## Delegated Action of the Executive Director

<b>PROJECT</b> <b>New Fence and Retaining Wall at the Embassy of Bangladesh</b> International Chancery Center 3510 International Drive, NW Washington, DC	<b>NCPC FILE NUMBER</b> 1844
<b>SUBMITTED BY</b> United States Department of State	<b>NCPC MAP FILE NUMBER</b> 72.10(38.00)44599
	<b>ACTION TAKEN</b> Approve preliminary and final site development plans
	<b>REVIEW AUTHORITY</b> Approval of Projects at the International Center Per Section 4 of the International Center Act (Public Law 90-553, amended by Public Law 97-186)

Figure 1 Embassy of Bangladesh Site Plan – Proposed Fence at the rear yard, and retaining wall with fence on top at the east side yard.

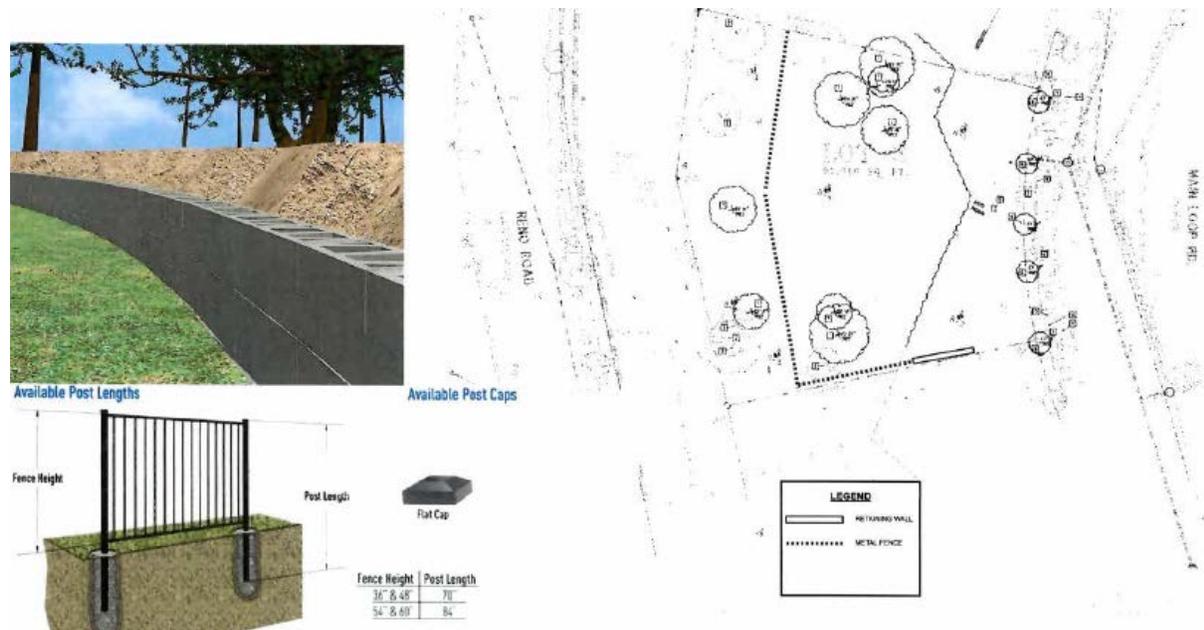
The project is needed to increase security along the rear and side yards of the Embassy. The scope of work entails excavating and leveling soil; installing footings; installing metal fence posts and railing system; building a low cinder block retaining wall; and adding a wall cap. The proposed wrought-iron black fence will be approximately 200 feet long by six feet tall, and will be located at the rear yard along Reno Road. The fence will connect to existing adjacent fences around the site. The proposed fence will have two by two inch posts which will run 16 inches underground and filled with concrete. The material and design of the new fence will be compatible with the adjacent fences. The fence will step down to follow the existing topography.

Due to the higher elevation of the recently constructed Moroccan Embassy as a result of regrading, a retaining wall is needed between the boundary line of Bangladesh and Moroccan Embassies to prevent potential landslides during heavy rain and snow. Therefore, the project also entails constructing a two-foot tall concrete retaining wall with a four-foot tall iron fence on top. The total height of the fence and retaining wall will be six feet. The retaining wall will be approximately 100 feet in length and should not be visible from street level. As such, the retaining wall will not have any viewshed impacts. Further, the fence and retaining wall will not require any tree removal.

The proposed fence and retaining wall will be located on the Embassy lot line. The fence and retaining wall will reach a total height of six feet, as such they will remain below the maximum height prescribed in the *Development Controls*. The design of the fence will have a similar appearance to adjacent existing perimeter fences, which are installed at the Embassies of Ghana and Morocco. In addition, the fence is compatible to the existing fence installed along the front yard of the Embassy of Bangladesh along International Drive.

Pursuant to delegations of authority adopted by the Commission on October 3, 1996 and per Section 4 of the International Center Act (Public Law 90-553, amended by Public Law 97-186), I approve the preliminary and final site development plans for the New Fence and Retaining Wall
